Addendum Number	Date	Description
1	10/27/11	Geotechnical Recommendations for Temporary Excavations
2	5/8/12	Response to Geotechnical Comments, City of Santa Monica Review Sheet (attached)

Addendum 2
Response to Geotechnical Comments
City of Santa Monica Review Sheet
Proposed Santa Monica Pico Branch Library
Virginia Avenue Park
Santa Monica, California
Building & Safety # 12PC0040
GeoDesign Project: SMonica-10-01

LOR Geotechnical Group, Inc. (LOR), acting as a review consultant for the City of Santa Monica, issued comments to our report in a Geotechnical Review Sheet dated February 16, 2012 (LOR Project No. 62739.246).

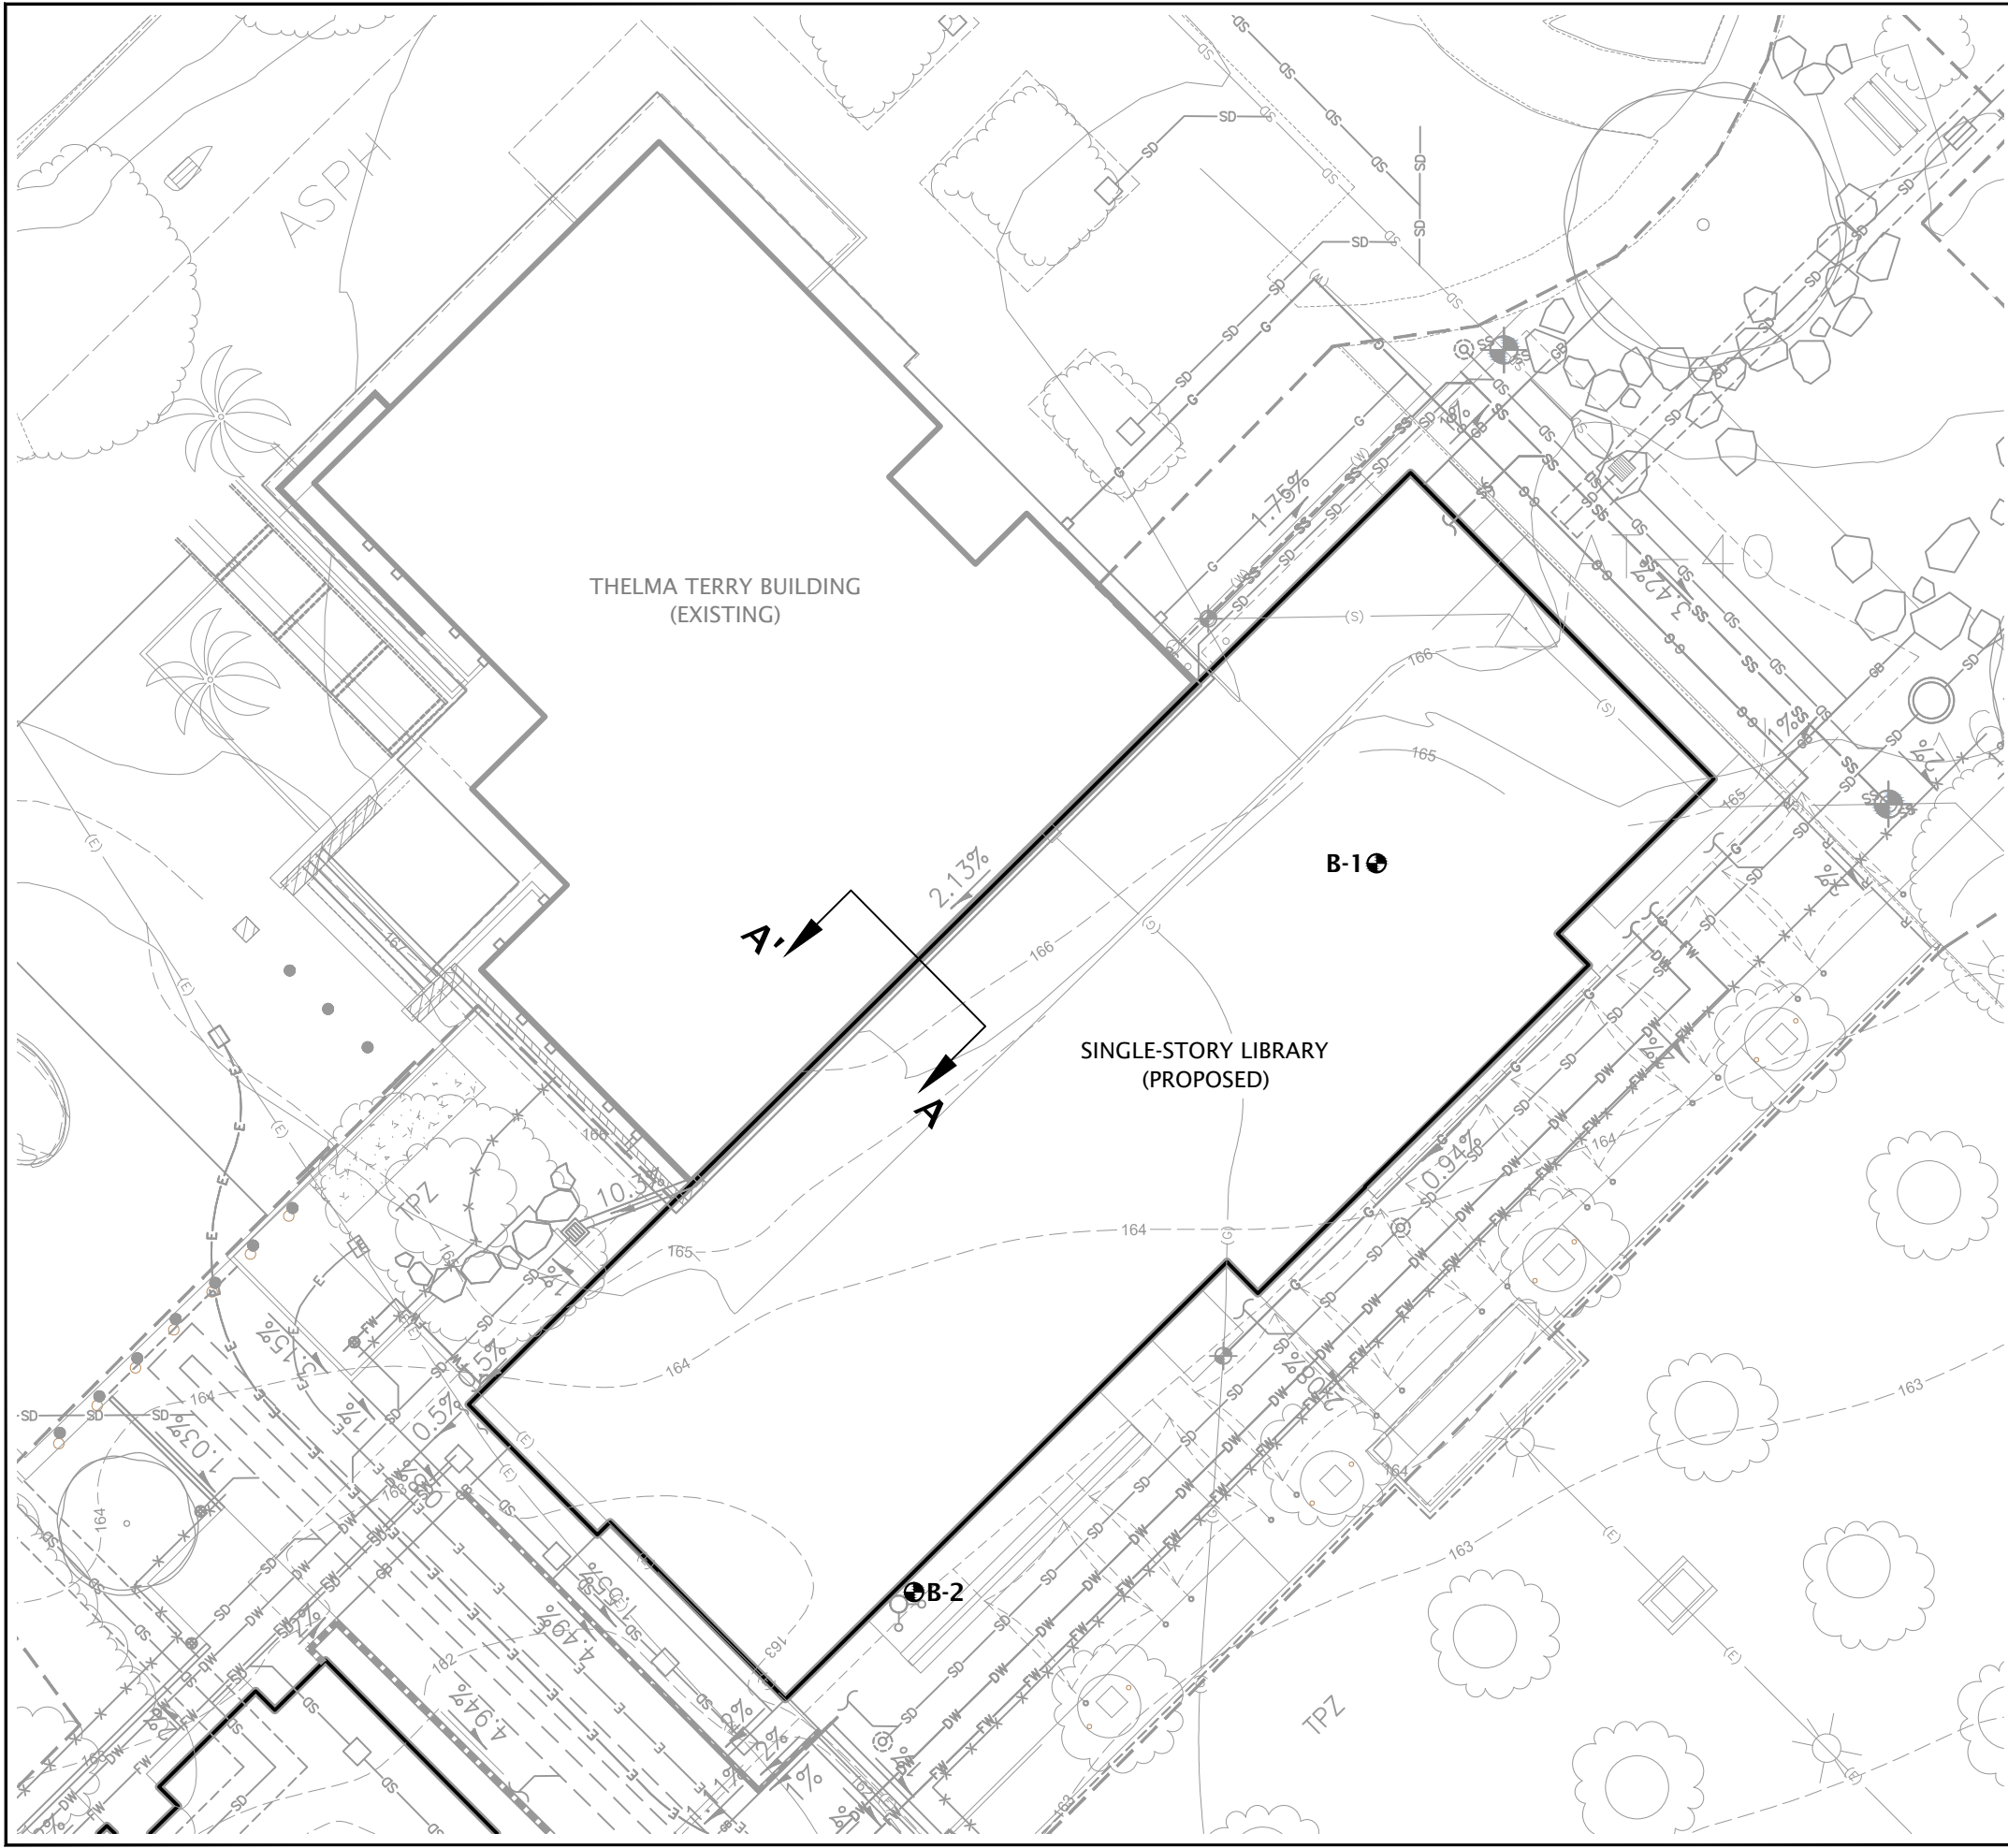
A tabulation of recorded peak ground accelerations from nearby recording stations for major events affection Santa Monica shall be summarized in tabular form. This tabulation shall include the identification of the recording station, peak ground acceleration, event, date of event, epicenter distances, magnitudes, and distance between recording stations and the site. A map showing the locations of the stations and the site shall also be included (Section 3.3 of the Guidelines for Geotechnical Reports, City of Santa Monica, dated March 2010).

As indicated in Section 3.3 of the *Guidelines for Geotechnical Reports, City of Santa Monica (March 2010)*, only the Northridge event needs to be considered. The Northridge earthquake was a magnitude 6.7 earthquake that occurred in Northridge, California, on January 17, 1994.

Recorded peak ground accelerations from recording stations within a 5-mile radius for the Northridge earthquake are summarized in Table 1. Table 1 includes the identification of the recording station, peak ground acceleration, epicenter distances, and distance between recording stations and the site.

A map that shows the location of the recording stations is included as Figure A-1 (Attachment A).

2121 Towne Centre Place - Suite 130 Anaheim CA 92806 Off 714.634.3701 Fax 714.634.3711	SMONICA-10-01	TYPICAL CROSS SECTION A-A'	
	MAY 2012	PROPOSED PICO BRANCH LIBRARY SANTA MONICA, CA	FIGURE A-3

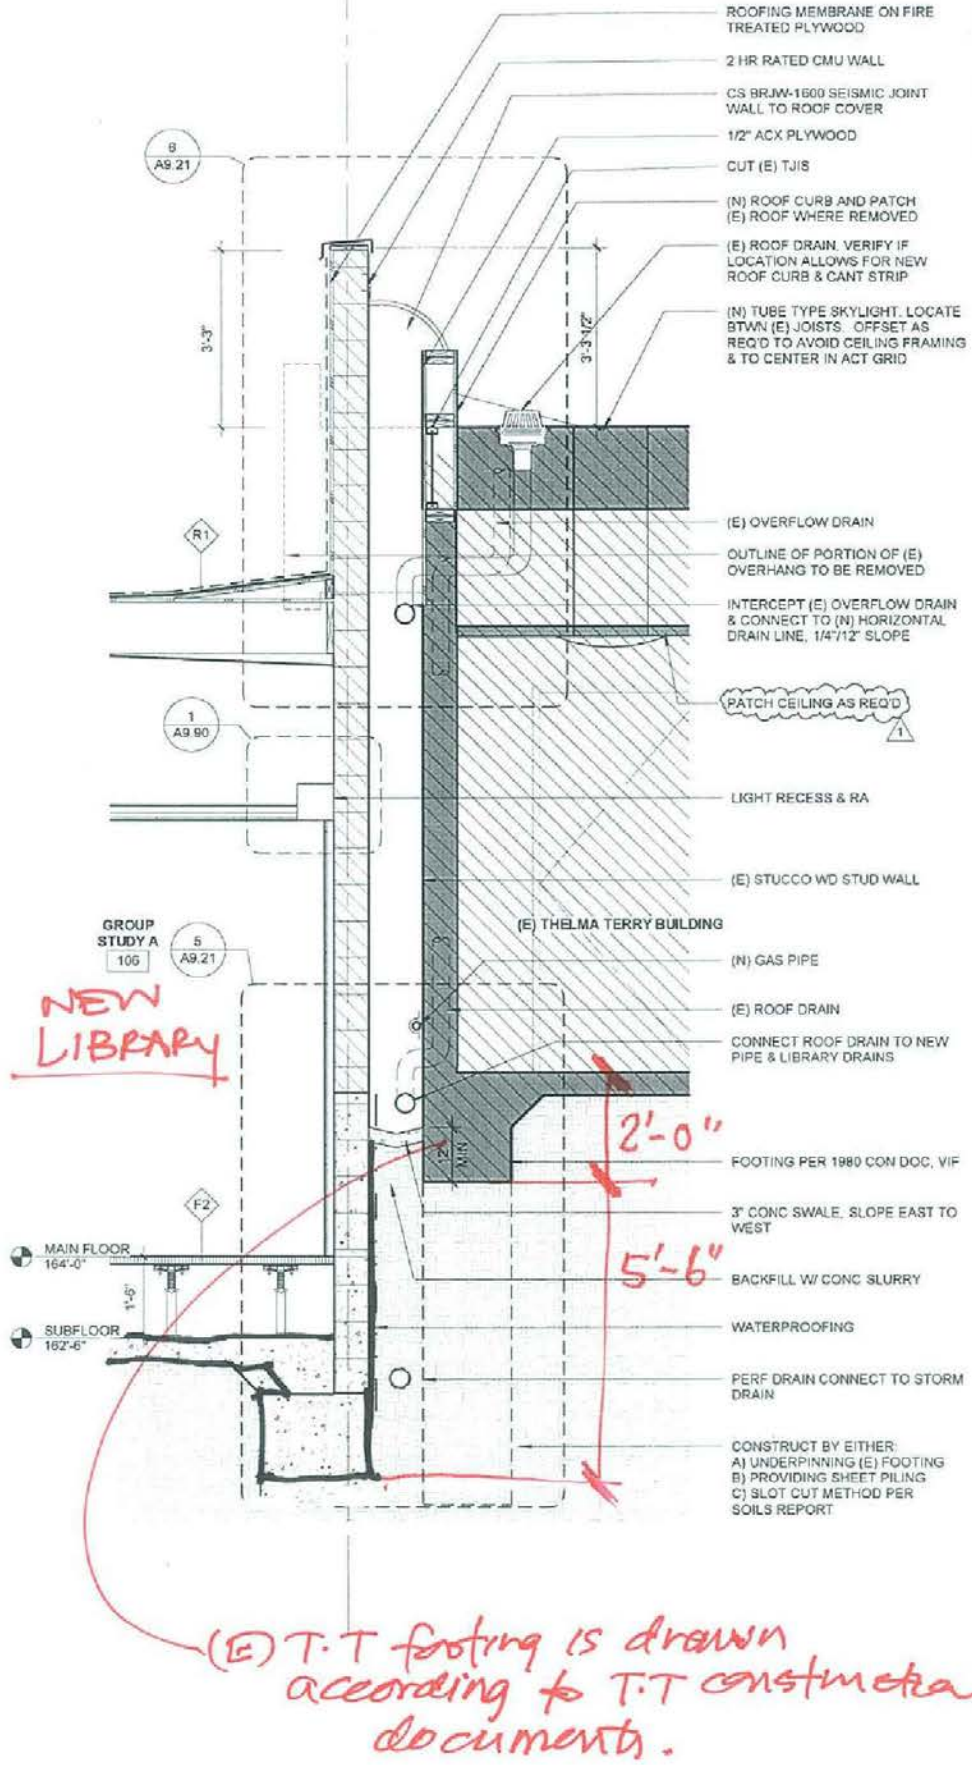
The report should evaluate the temporary stability during grading, foundation construction, and retaining wall excavations as outline in Section 3.8.8 of the current city guidelines (March 2010).

On April 26, 2012 you provided us with an updated sketch that indicates the new library footings will extend a maximum depth of approximately 5.5 feet below the bottom of the Thelma Terry Community Center building foundation. Figures A-2 and A-3 depict the current proposed conditions.

The on-site soils consist of silty sand and will stand vertically for this depth when considering the loading applied from the Thelma Terry Community Center building and temporary shoring will be required to construct the necessary excavation.

Temporary shoring may consist of soldier piles and timber lagging and should be designed to limit the lateral deflection to ¼ inch or less at the top of the shoring.

Soldier piles may be installed in a manner so that they can also serve to underpin the existing Thelma Terry Community Center building foundation or the shoring may be designed to resist surcharge loading from the existing foundation.

FIGURE B-2

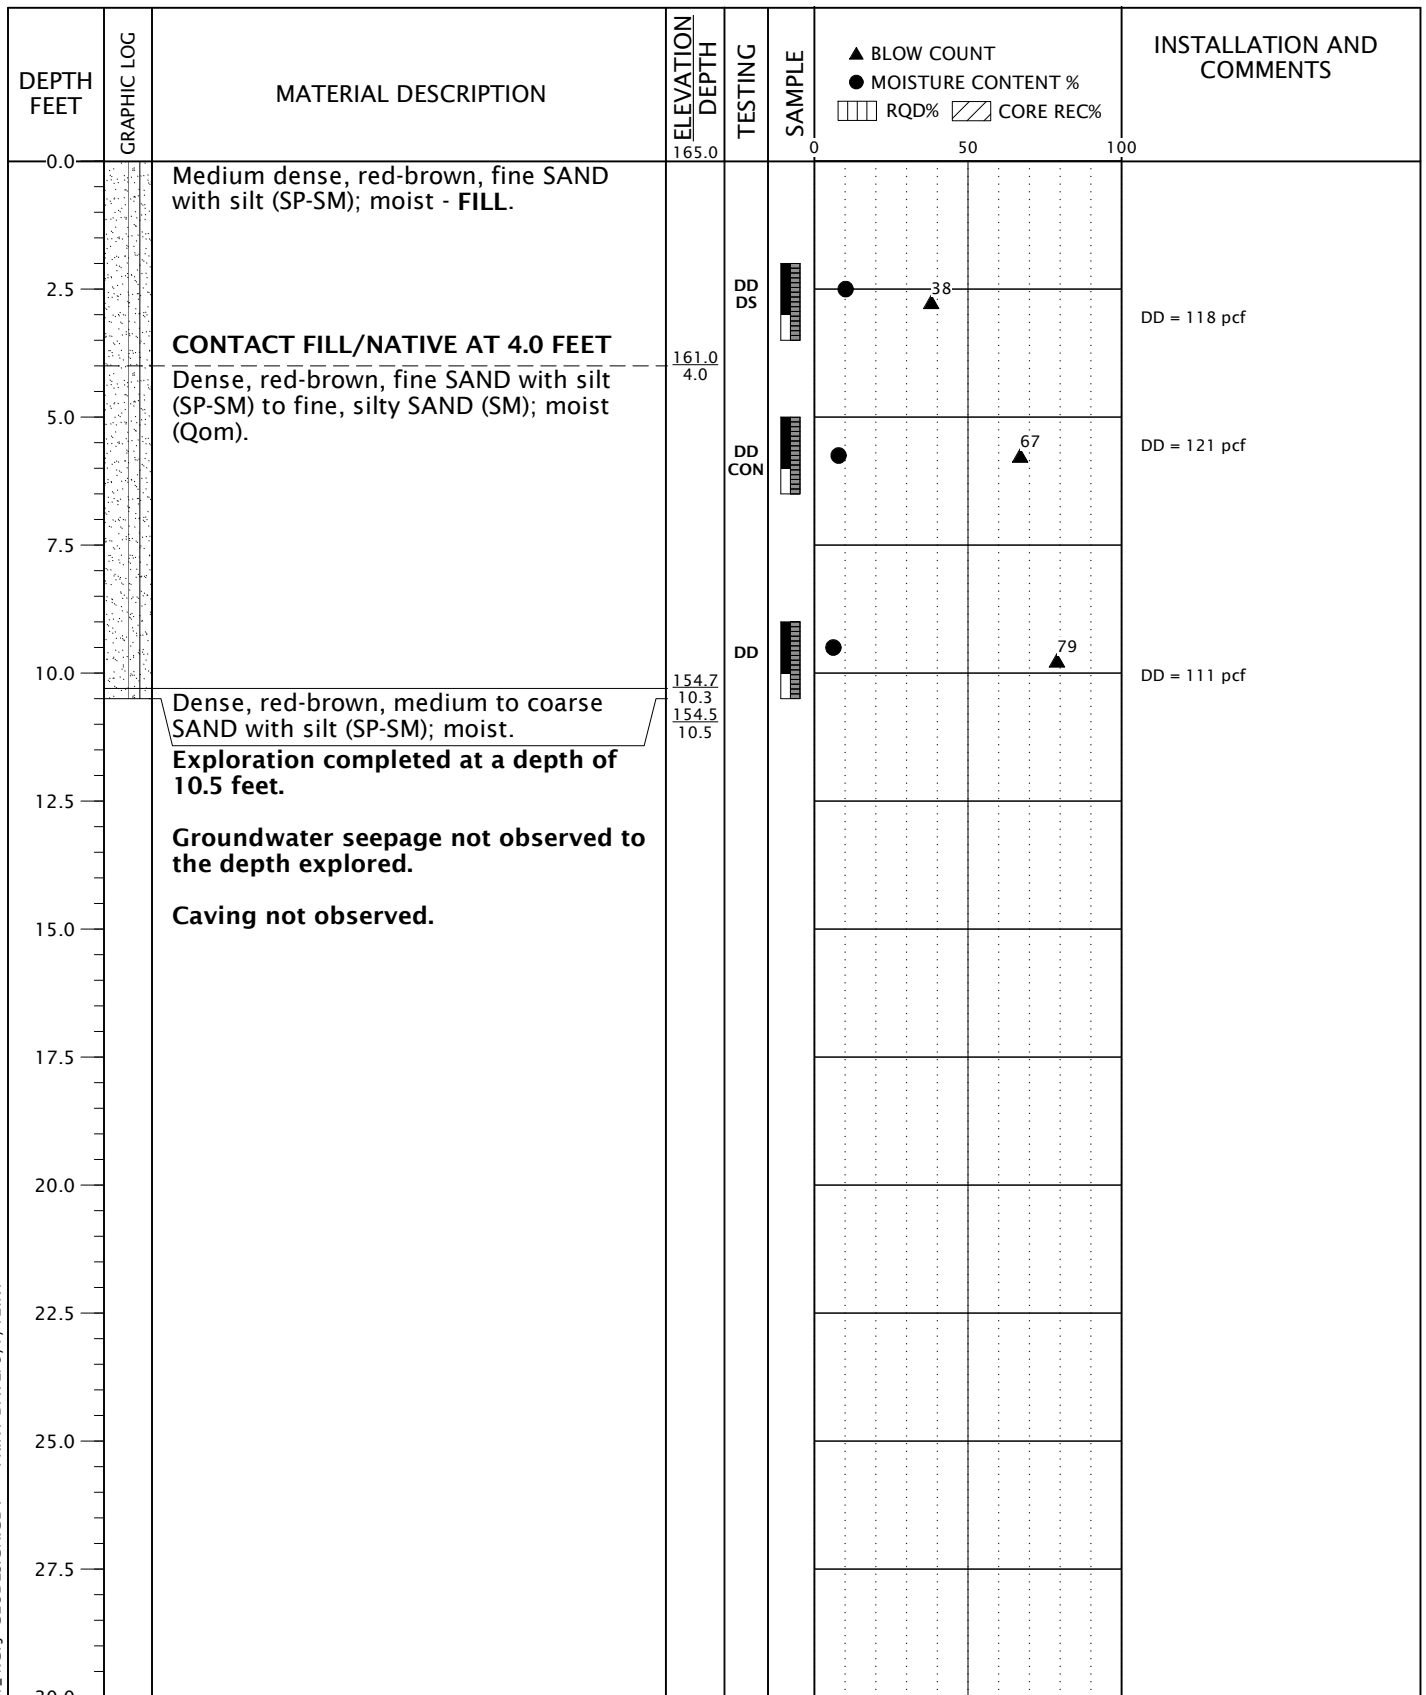
The boring logs should identify the native soil contact.

We have revised the boring logs to clearly identify the contact between the fill materials and native soils. The logs are included in Attachment B.
